# UNITED STATES PATENT AND TRADEMARK OFFICE

APPLICATION NO.	FILING DATE	FIRST NAMED INVENTOR	ATTORNEY DOCKET NO.	CONFIRMATION NO.
10/661,847	09/12/2003	Charles Edward Boardman	24-AT-135243	8534
7590 Patrick W. Rasche Armstrong Teasdale LLP Suite 2600 One Metropolitan Square St. Louis, MO 63102		11/19/2007	EXAMINER GREENE, DANIEL LAWSON	
			ART UNIT 3694	PAPER NUMBER
			MAIL DATE 11/19/2007	DELIVERY MODE PAPER

# Office Action Summary

## **DETAILED ACTION**

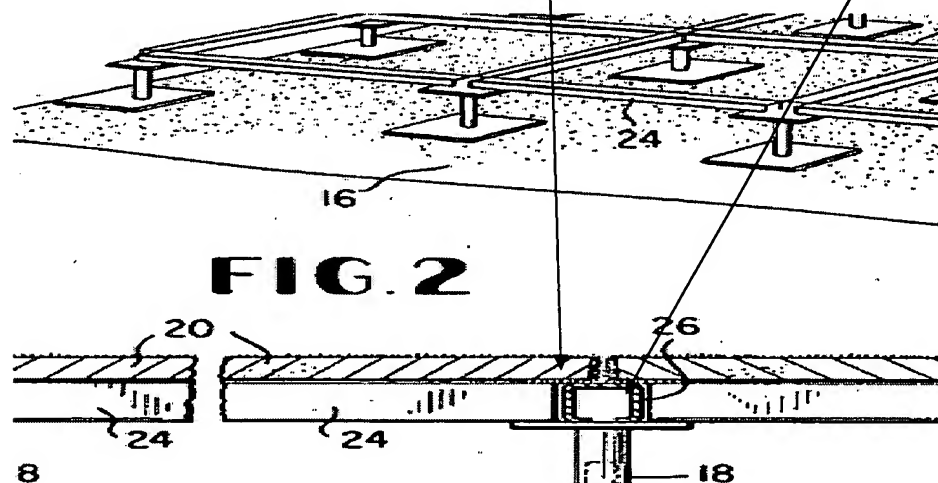
Anthony does not appear to expressly disclose;

that there is at least one groove in said bottom surface,

each said groove is sized to engage one of said support beams where a portion of said beam is positioned in said groove and

said removable support plate is in direct contact with said beam.

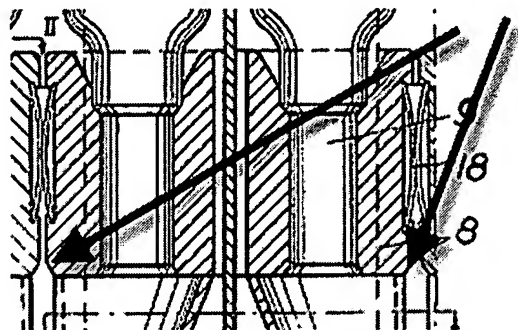
So to be clear, the Examiner has modified Anderson by removing the posts 52 and replacing them with the beam support structure of the secondary references and further utilizing the teachings of equivalency in replacing the support system of Andersons post and hole with a beam system and a groove that runs around the entire circumference of support plate 41 as taught by either Bettinger Figures 1, 2, 3, 9 or Naka Figure 10, etc. With these modifications the support plates of Anderson would actually sit down onto a support beam structure in the same manner as applicants

**Regarding claims 6 and 15** and the limitation wherein each said removable support plate comprising at least one support plate flow passage, see for example, Figure 1 and col. 4, lines 10-18.
